## **ZONING CHANGE REVIEW SHEET**

CASE: C814-2018-0121 -- 218 South Lamar

TO: PUD

ADDRESS: 218 South Lamar Boulevard Southbound

4-Lane Divided, 60' Curb-to-Curb  
Back-of-Curb Condition F  
Barton Springs Road to Riverside Drive

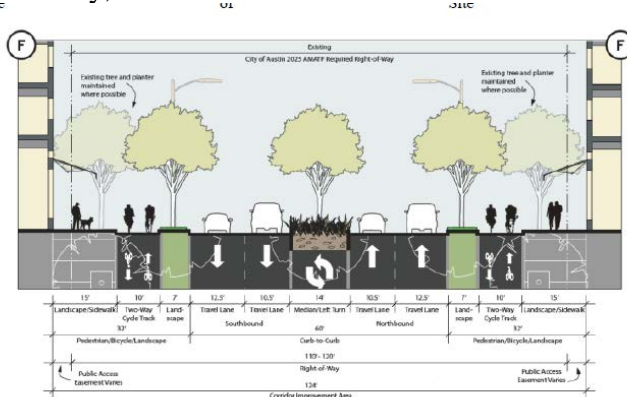
TR2. Include the below streetscape in the land use plan. Contact this reviewer for a more legible copy of it if necessary. This project is adjacent to a street that has been identified in Austin's Corridor Mobility Program (S Lamar). The sidewalk and bicycle facilities shall comply with the required cross-section at the time of the site plan application. The cross section that will be required is shown below. Find additional information about the Corridor Mobility Program here: <https://data.austintexas.gov/stories/s/Corridor-Mobility-Program/gukj-e8fh/>. Any proposed curb relocations on S Lamar requires coordination with the Corridor Planning Office and Bicycle Program. The cross section will include a 7' planting zone with street trees, a 10' two-way cycle track, and a 15' clear zone all behind curb. Additionally, a protected intersection will be required at Toomey, to be reviewed at the time of Site Plan.

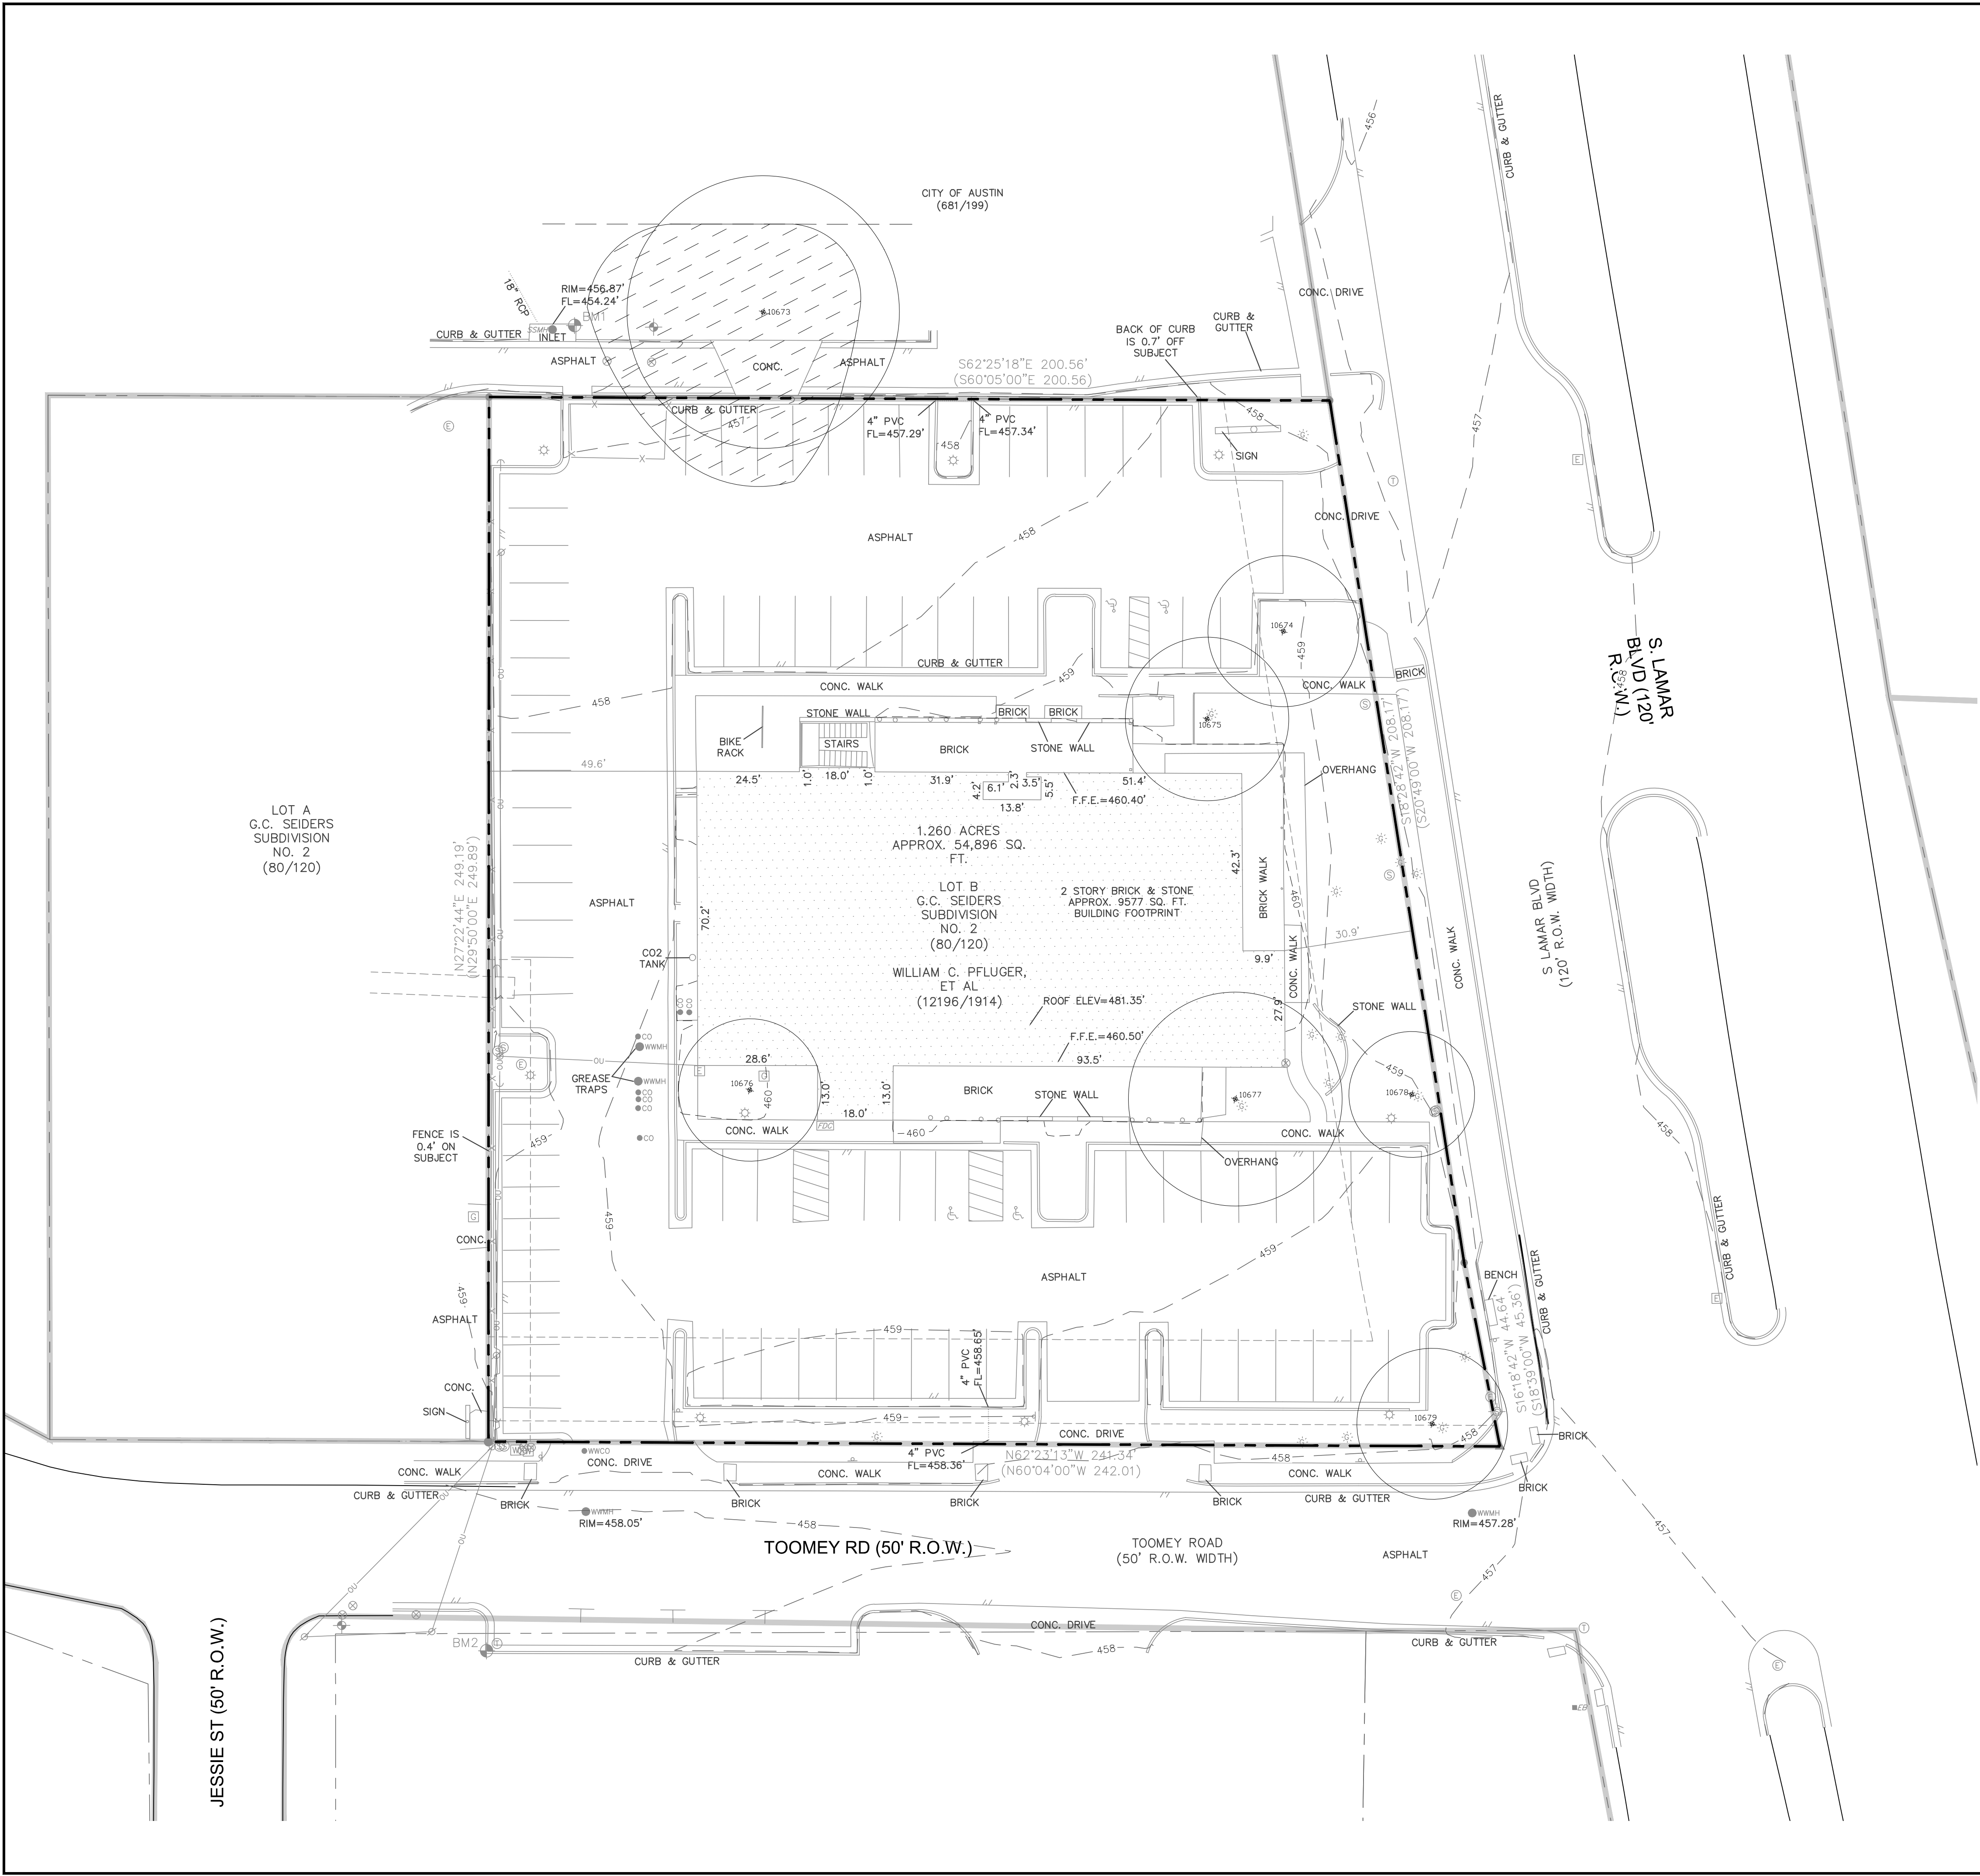
HT 1: Thank you, for providing a tree survey for the Heritage tree to the north of the PUD between the northern offsite driveway and the Topher Theater. Some of the information requested in the previous comments for the development assessment have not been provided with this submittal. Please show this tree's current growing area and surrounding hardscape. Please also provide a canopy survey for the tree and include information about how much canopy the PUD would affect if the building setback lines are modified to 0 feet off the property line as proposed by the PUD.

UPDATE 1: Thank you for the canopy survey. This original request came in two parts for evaluation. You have provided a canopy survey on paper without including the information as to how much canopy the PUD would affect if the building setback lines are modified to 0 feet off the property line as proposed by the PUD. For this, the services of a third party arborist would be required. Also, the current survey does not appear to take in all of the hardscape surrounding the open area of this tree for evaluation. Comment pending.

UPDATE 2: Thank you for the additional information. Staff agrees that it is close but does not appear that the building would greatly affect the canopy of this tree. What the exhibit does not show is the limit of the underground parking garage and potential disturbance that its construction proposes that could affect the tree's canopy. Also, the initial comment requested the information based on the potential canopy the PUD would affect if the building setback lines are modified to 0 feet off the property line as proposed by the PUD. Comment still pending.

UPDATE 3: Staff has discussed in email and offline that this information be reviewed and provided by a certified arborist. Simply surveying the canopy up to the property line and not having an arborist assess the potential cuts at that location does not confirm what may be the overall required pruning, if the pruning were to need to go all the way back to the main trunk of the tree to be done correctly. Please have this assessment done by a certified arborist and respond based on the potential impacts if building setback lines are modified to 0 feet off the property line as proposed by the PUD. Comment still pending.
